**ITEM #1      WORKSHOP – Tinley Park Plaza Redevelopment, 15917-16037 S. Harlem Avenue -  
Special Use for Planned Unit Development & Site Plan Approval**

# PLAN COMMISSION STAFF REPORT

Special Use for a Planned  
Unit Development (PUD)  
with Exceptions  
Site Plan Approval

With the uncertainty for the future of the retail market, the redevelopment of **Tinley Park Plaza** is critical for the success of the Harlem Avenue commercial corridor. The antiquated shopping center (constructed in 1974) comprises over 22 acres and approximately 244,132 sq. ft. of retail/service space. Currently it is experiencing vacancies upwards of twenty percent with significant leases expiring within the next few years. Brixmor Property Group is proposing a complete remodel of the plaza. The project is planned in phases with the first phase completed in 2015 involving the construction of a 9,100 sq. ft. multi-tenant retail building at the north end of property. The current proposal (yellow highlighted area) represents the second phase of the project which will involve the demolition of approximately 87,000 sq. ft. of existing buildings (red dashed line) and the construction of approximately 67,110 s

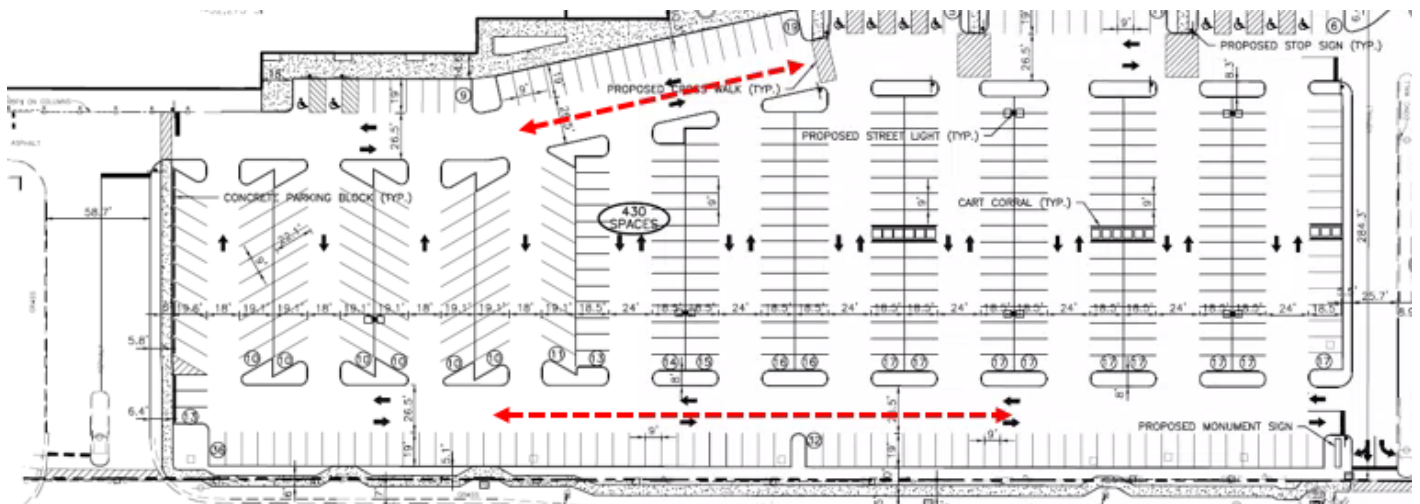
The Village code requires 26' drive aisles in parking lots. The main aisles in the plaza have been designed at 26.5' as noted by the red arrows below. The diagonal parking aisles are 18' as required by code. The aisles in the north parking lot are 26' or greater. The remaining aisles are noted as 24' wide. The Village has approved parking aisles at 24' in other developments such as Sam's Club, Marriott hotels and the Brixmor outlots; none of which have proven problematic to traffic flow. Meeting the 26' requirement code will result in loss of parking and landscape buffers. If the Commission supports this change it will need to be noted as an exception to the Village Code as part of the PUD.

***Open Item #1: Discuss the exception to the required 26' aisle width noted in several areas of the parking fields. If supported by the Commission this will be noted as an exception to the PUD.***

Proposed  
North Lot

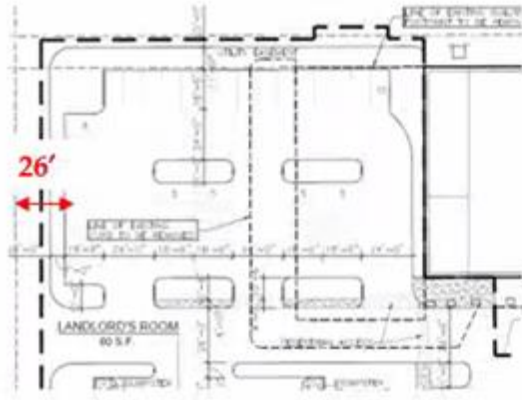
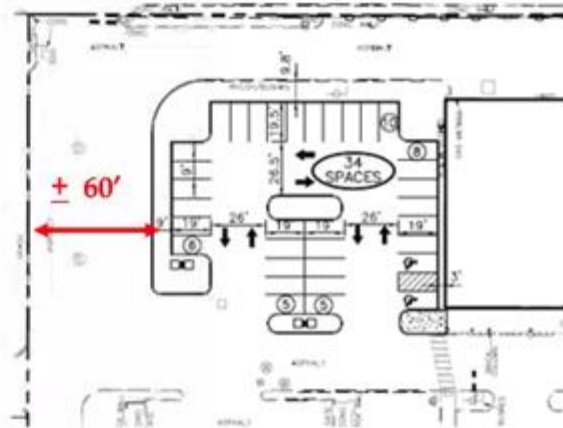
While staff supports some modification to this area to remedy the damage to the landscape area and awkward drive aisle transitions, the width of the east-west aisle is excessive and results in an unsafe transition for vehicles traveling west or east as the aisle increases from the existing 26' wide aisle to over 60'. Staff has recommended the engineers revise this section and the corner radius to minimize driving over the curb. The current proposal also results in a loss of 8 parking spaces.

**Open Item #2: Revise configuration of east-west access lane to better define and distinguish truck traffic from vehicular traffic.**

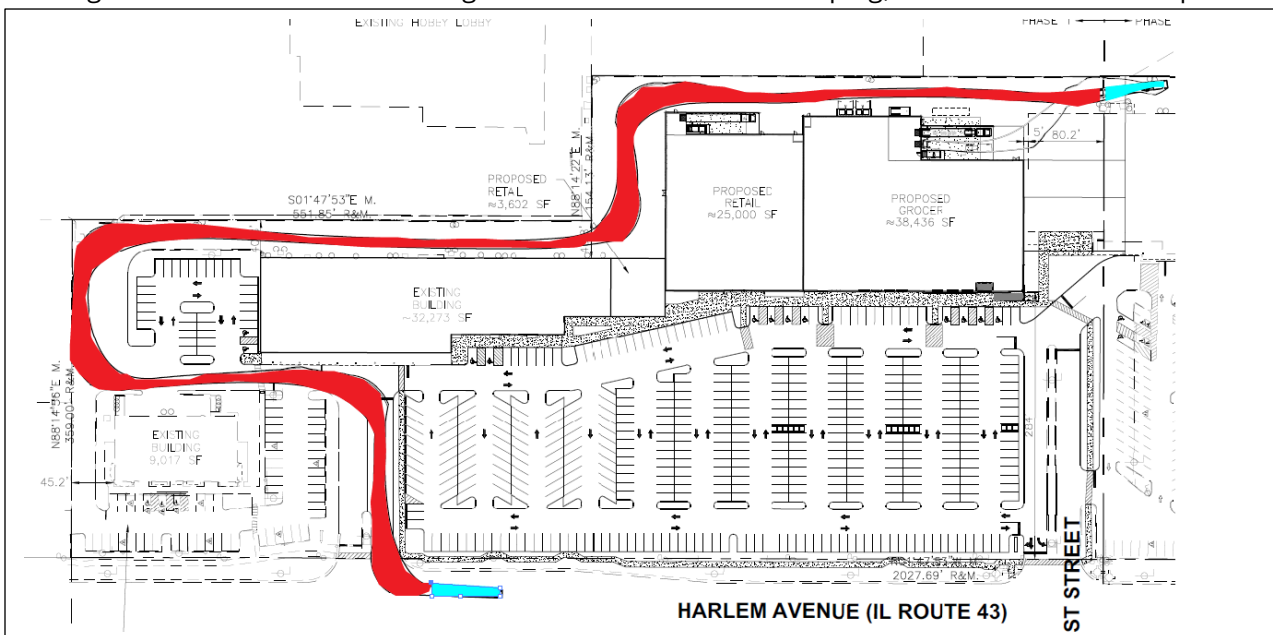
Delivery access. The east side, or rear of the building currently functions as the delivery aisle for all the tenants. There are multiple access points depending on where the tenant is located and the configuration of the docks. The additional width of the east-west lane on the north side of the property provides the necessary lane width to accommodate these turning movements without running over the curb and landscaping, however Staff has requested further

explanation of how the access lane will be striped to clarify lane usage for vehicular traffic. Staff has also requested the north parking lot be reconfigured to ensure safe access at the northwest corner of the lot. The grocer has provided a truck study that follows the path shown below but does not encroach in on-coming traffic lanes. These plans will be made available prior to the meeting and will be distributed upon receipt.

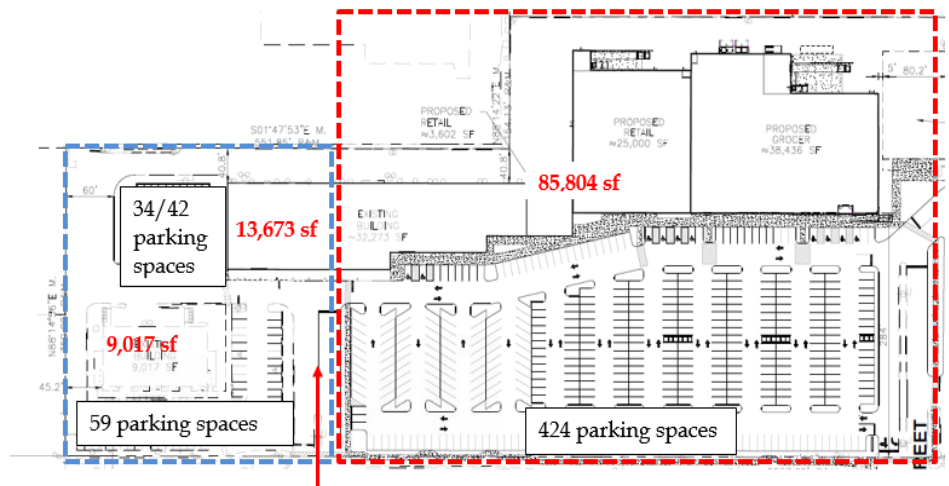
Mechanical systems. All mechanical systems must be screened from view. The applicant has provided elevations (north, east and south) showing some of the roof top RTUs. Staff has requested verification that they cannot be seen from public view. A site line study is being prepared and will be presented at the workshop.

**Open Item #7: Verify rooftop mechanical units are not visible from public view.**

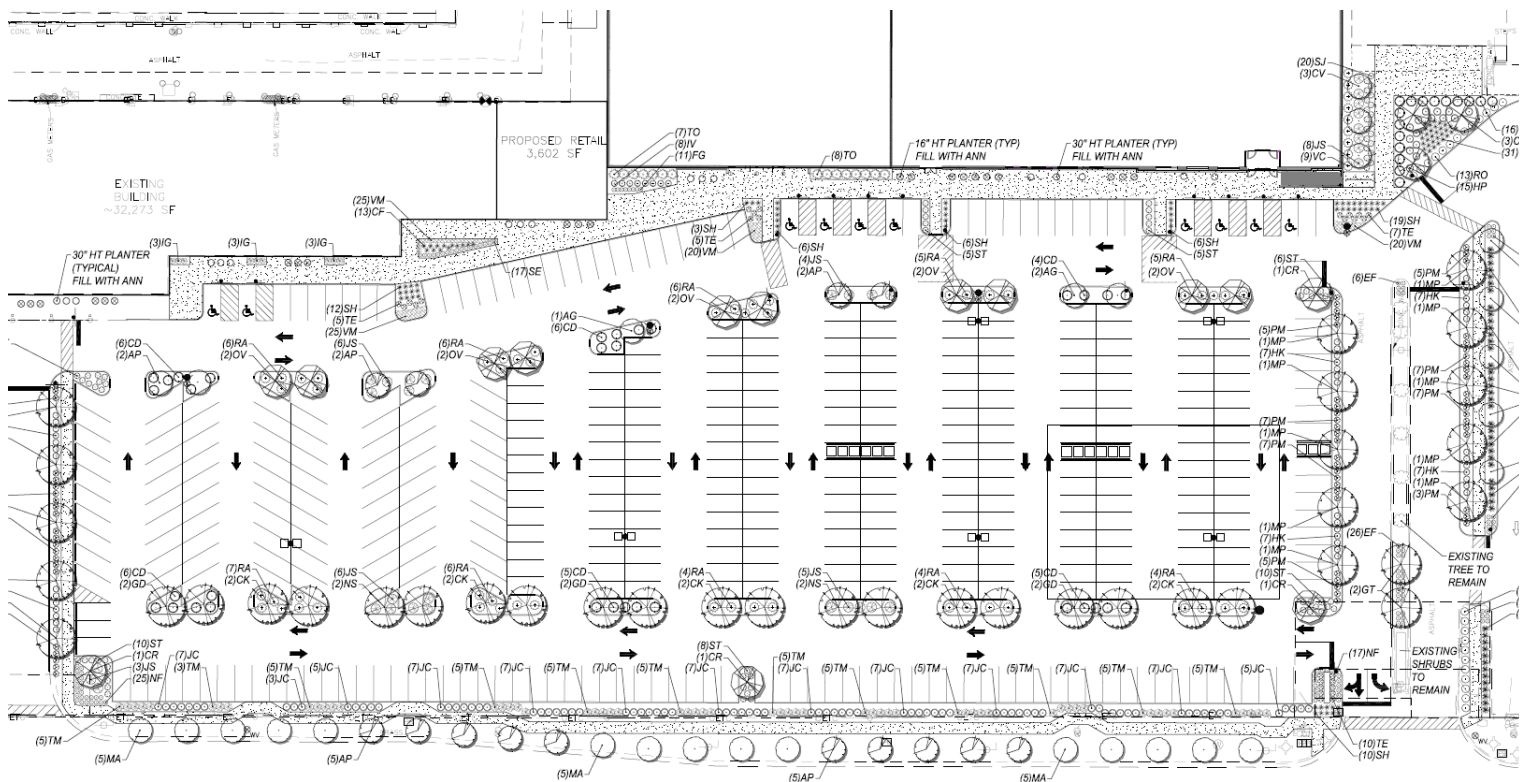
**Open Item #10: Discuss the appropriateness of the proposed building materials; identify any deviation from code as an exception to the PUD.**

### HARLEM AVENUE FRONTAGE

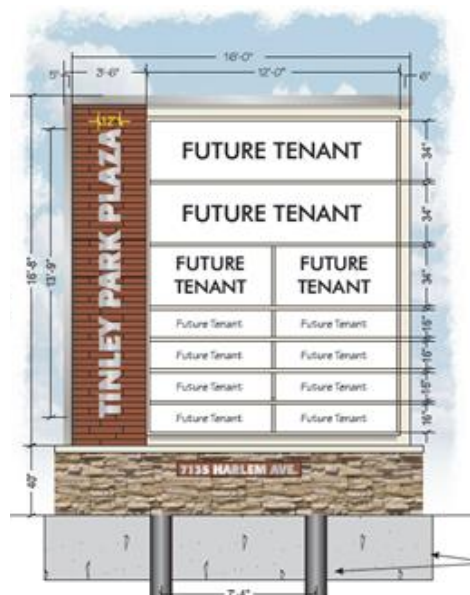
Due to the limited parkway area along Harlem Avenue and constraints of the existing parking field/access configuration, staff supports increasing the size of shade trees from 2.5" cal. to 4" as a means to mitigate the deficiencies in bufferyard plantings; this will also provide for a more instant dramatic impact. The bufferyard for the east property line is accomplished with the existing solid wood fence. Any deficiencies in the fence will need to be corrected as a condition of PUD approval. All parking islands have been increased from the original proposal to a minimum width of 3.5' with many meeting the 9' width requirements. All planting areas will be irrigated; planting areas along the foundation will be required to have couplers to allow for easy irrigation of movable planters.

**Open Item #12: The fence at the east property line must be in good repair as a condition of the PUD. Discuss the recommendation for additional foundation plantings in front of the grocer.**

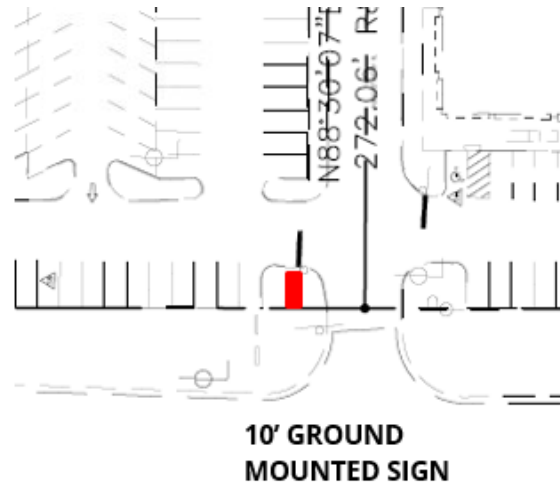
Free-standing signs must be set back a minimum of ten feet (10') from the property lines and shall not obstruct clear sight triangles near intersections. The proposed 20' ground mounted sign and the 10' ground sign at the south end of the plaza do not meet these requirements. The 20' sign cannot meet the required setback without closing the access from the parking lot to the 161<sup>st</sup> Street access therefore this exception will need to be noted as part of the PUD approval. The same configuration exists for the 10' sign at the south end of the plaza and will also require an exception. The 10' ground sign at the north entrance from Harlem does meet the 10' setback requirement.

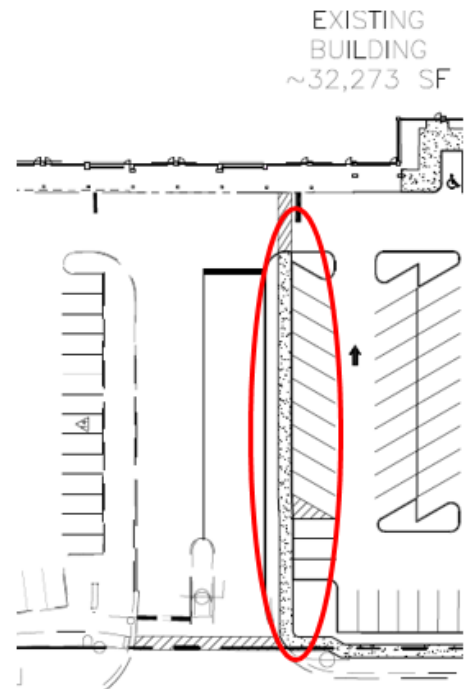
3. Internal sidewalks: Per Section III.U.3.d. "the Site Plan provides for the safe movement of pedestrians within the site." The sidewalk fronting the in-line stores as well as the new retail stores must be wide enough to accommodate ADA access and landscaping. **Response: The sidewalk width in front of the building has been widened to 16.' Additionally, foundation plantings have been added as indicated on the revised Landscape Plan. The pinch point at retailer has been widened to 10', however the building corners have not been truncated and the square corner maintained. These revisions are positive additions to the plan.**

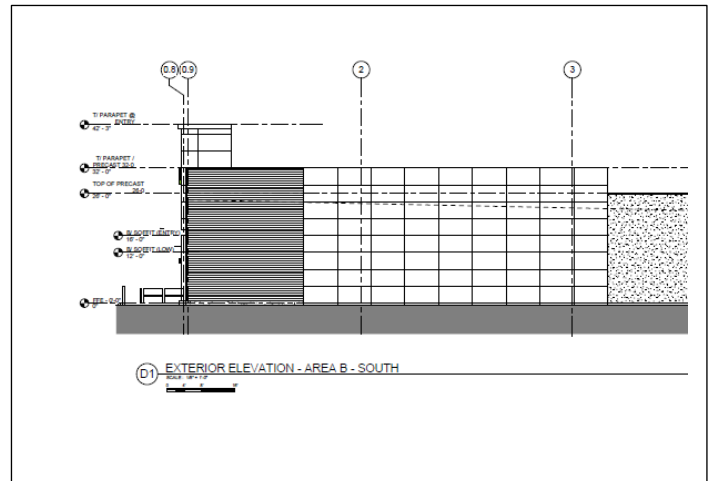
10. Exterior Building Materials – The building material types and percentages are not indicated on the proposed elevations. ...For the proposed building size, the code requires that 25% of the building utilize face brick or decorative stone; the remaining 75% of each façade must be constructed of an approved masonry material as defined below. ...Please provide a detailed list of how your proposed architecture conforms or deviates from the building material requirements. Overall staff is supportive of the in-line tenant architecture and materials however staff will need to provide information to the Commission/Board on any deviations from Code. **Response:***Updated elevations with responses to these concerns will be provided under separate cover. Plans received still do not indicate percentages as required by code. Delivered to office .*
